No. 0751-157
ATA Code 51-00

SUBJECT: FLIGHT CONTROLS - PEDESTAL STRUCTURE - INSPECTION OF FLAP AND STABILATOR TAB CONTROL PEDESTAL

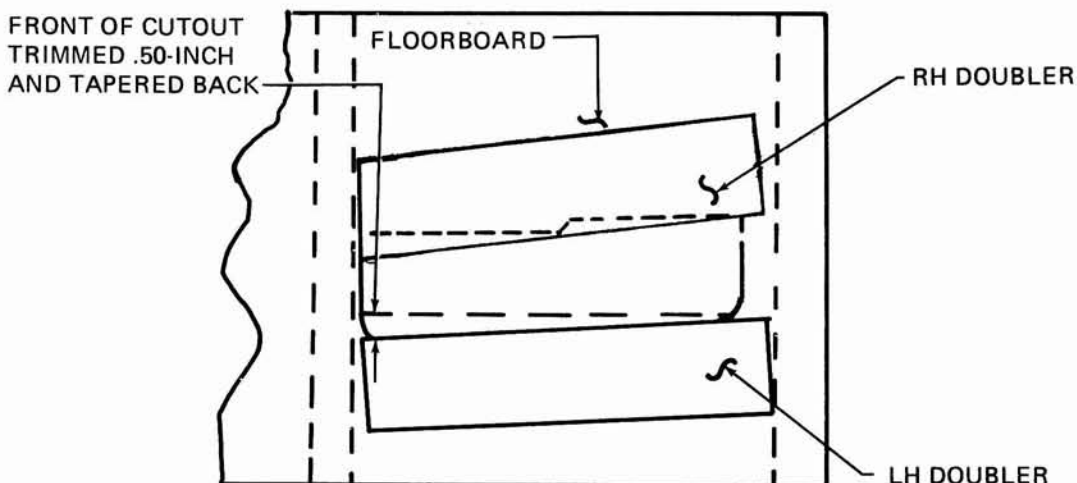
Measure the distance between the center line of the fuel selector valve handle shaft and the center line of the flap handle to determine if this modification is required. If the distance is less than 2.9 inches, proceed with the following steps.

3. Trim the cutout in the floor .50-inch as shown in the illustration and fabricate two doublers 2.0 x 9.0-inches using .040-inch 2024-T3 aluminum alclad flat sheet.

4. Install the aft left hand screw attaching the pedestal to the floor but do not tighten.
5. Move the front of the pedestal .50-inch to the left of its original position and install one doubler on the left hand side of the cutout between the pedestal and the floorboard, flush with the trimmed edge of the cutout (see illustration). Using the existing holes in the pedestal as guides, drill holes through the doubler and floorboard with a No. 30 (.1285-inch) bit and trim the doubler to fit as required. Attach the doubler and pedestal to the floor with temporary fasteners.

6. Install the right hand doubler as shown in the illustration. Drill holes through the doubler and pedestal using the holes in the pedestal as guides with a No. 30 (.1285-inch) bit and attach the doubler and pedestal to the floor with temporary fasteners.

7. With a No. 30 (.1285-inch) bit, drill 6 holes, equally spaced, along the outboard edges of each doubler, with an edge distance of $.25 \pm .03$ -inch.
8. Determine how much the aft right hand hole will have to be elongated to accept the screw that was removed in step 2, remove the fasteners and elongate the hole as required.
